Peer Review
of
The Submitted Photo Simulations of the Proposed Water Tank
Dated November 7, 2018
at
Station #115
2783 Melendy Drive
San Carlos, CA

OASIS ASSOCIATES
LANDSCAPE ARCHITECTURE + PLANNING

December 6, 2018

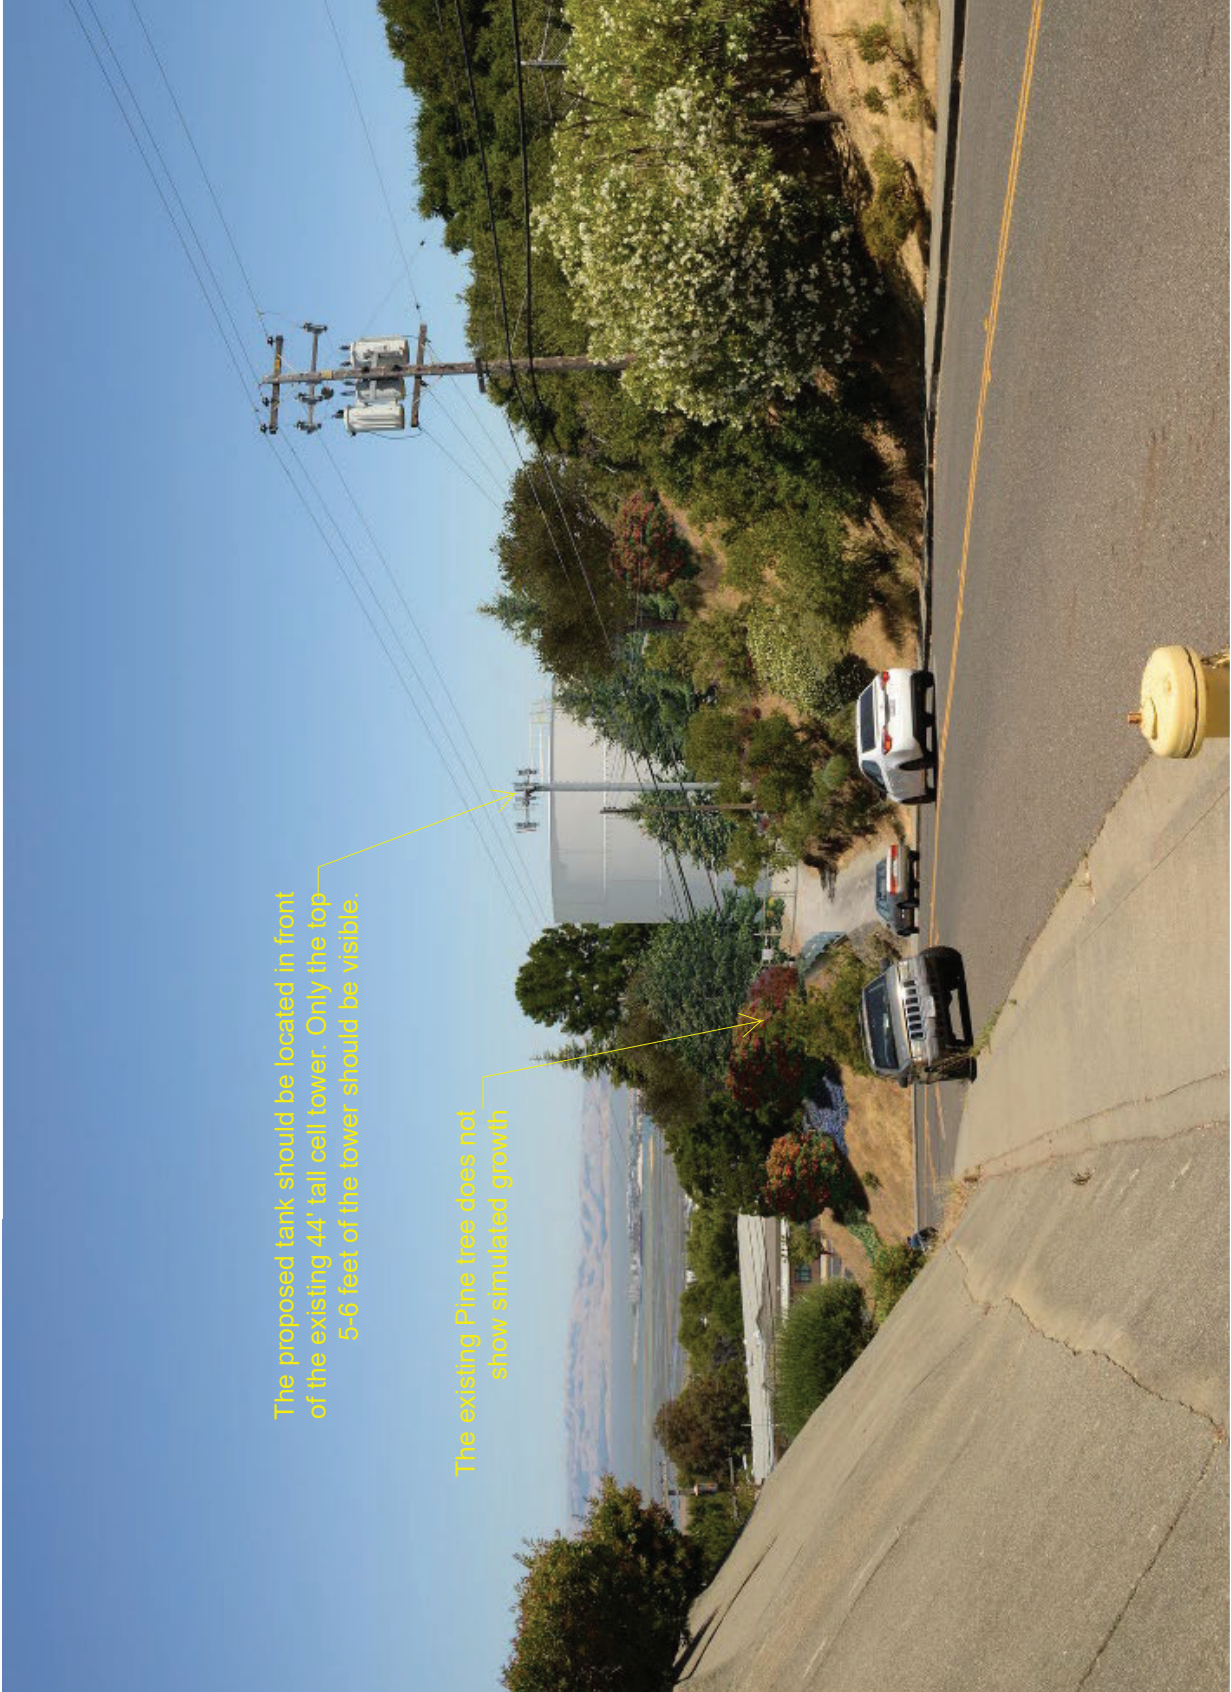
Using a 10-scale ruler and an 8.5x11-inch hard copy, full-bleed print of the photo simulation, we found that the cell tower pole peaks above the Water Tank by 10 units and the existing and proposed water tanks are 14 units apart. According to the plans, we know that the tower is 6.3 feet taller than the proposed Water Tank, and the horizontal distance between the two tanks is 25 feet. We found that the ratio of vertical distances: (6.3:10) is .63 and the ratio of horizontal distances: (14:25) is .56. The cell tower pole appears bigger because it is 25' closer to the photographer's point of view, thus a .07-unit discrepancy. **Since the horizontal and vertical distances are consistent with each other, we can infer that the simulated Water Tank has been accurately placed in the project site.**

We reviewed the growth rates of the proposed Deodar Cedar (*Cedrus deodara*) and Coast Live Oak (*Quercus agrifolia*) trees within the viewshed. The estimated growth rate of a Deodar Cedar is 18 inches - 3 feet each year.² Coast Live Oaks grow rapidly at an average of up to 2 feet per year but slow down once mature.³ If planted as 6-foot-tall 15-gallon trees in Year 1, we can expect the trees to be at the simulated height in 12 years. **Based on our observations and calculations – utilizing the existing tank as a scaling object – it appears that the Cedar and Oak trees have been accurately scaled over a 12-year period in the simulation.**

We used the existing power pole at the north side of the project area as the scaling object at this perspective. The pole, measuring 25 feet tall, sits 14 feet to the left of the simulated Water Tank. At a pad elevation of 516.14, it is 4.32 inches lower than the Tank (an indiscernible amount). Drawing a line from the top of the pole to

intersect the Tank, we found that there is an additional 12.7 feet of Tank above the line. In total, the height of the simulated tower is approximately 37.7 feet which matches the proposed plan height. To measure the width of the Tank, we took the same pole dimensions and used a 10-scale ruler to horizontally measure 25 feet. The simulated Tank's horizontal distance, measured from the edge of the Tank (in line with the pole) to the ladder, came out to be 41 feet across. This matched the plan's width from the same two points. **The Tank is properly sized in the project area. However, its placement is inaccurate; the photo simulation shows the cell tower pole and the existing building in front of the Tank. The Landscape and Grading plans indicate that the cell tower pole and existing building should be behind the Tank, with a portion of the building sticking out on the left and the pole completely hidden from view.**

From our earlier observations regarding the estimated growth rate of the vegetation on site, we can conclude that the Pines and Cedars will reach the heights shown in the View 2C 12-year simulation. Toyon (*Heteromeles arbutifolia*) also exhibited growth in the photo simulation. This red-berried tree has an estimated growth rate of 1-2 feet each year.⁴ The simulation shows a 12-year Toyon at 15-20 feet tall which reflects the annual rate of growth. We noticed, however, that the existing power pole that we used as a scaling object in 'Year 1' has disappeared behind an existing Pine. **The power pole, indicated on the Landscape plan, should be in front of the existing Pine and behind the simulated Cedar and Oak growth with part of the top visible at this perspective.**

We utilized the height of the existing power pole, the distance between the Tank and the pole, and the height and width of the proposed Water Tank from the Grading plan to test the accuracy of the Water Tank's placement in this perspective. Size of the Tank was calculated as follows (units represent the measurements we gathered from the 8.5x11-inch photograph): $(16.5 \text{ units} \div 14 \text{ units} = 1.18)$ and $(45 \text{ feet} \div 37.7 \text{ feet} = 1.19)$. The results show that the horizontal and vertical dimensions of the simulated Water Tank are accurate at this view. Location of the Tank was determined in a similar manner, this time using the distance from the power pole to Tank and the height of pole, respectively: $(5.5 \text{ units} \div 9.5 \text{ units} = .57)$ and $(14 \text{ feet} \div 25 \text{ feet} = .56)$. **The calculations show that the Tank is properly sized in the project area. The photo simulation, however, shows the Tank's improper placement behind the cell tower pole. As indicated on the Landscape and Grading Plans, the cell tower pole is 25 feet behind the Tank. At this view, the observer should only see 5-6 feet of the cell tower pole above the Tank.**

The 6-foot chain link fence allowed us to gauge the growth of nearby vegetation. Cedars are shown at 15-20 feet tall, Toyon is shown at 15-20 feet tall and Coast Live Oak trees are shown at 15-20 feet tall – all exhibiting accurate growth rate patterns. Purple Hopbush (*Dodonaea viscosa* 'Purpurea'), is shown at this view closest to the chain link fence on the left side of the driveway. It can grow quickly – about 2 feet per year.⁵ The simulation shows it at 8-10 feet tall, **However, an existing Pine closest to Melendy Drive and on the left side of the project site driveway did not display any simulated growth from the Year 1 to Year 12 view. Additionally, the cell tower pole is still prominently displayed in front of the Tank and should be moved to the back.**
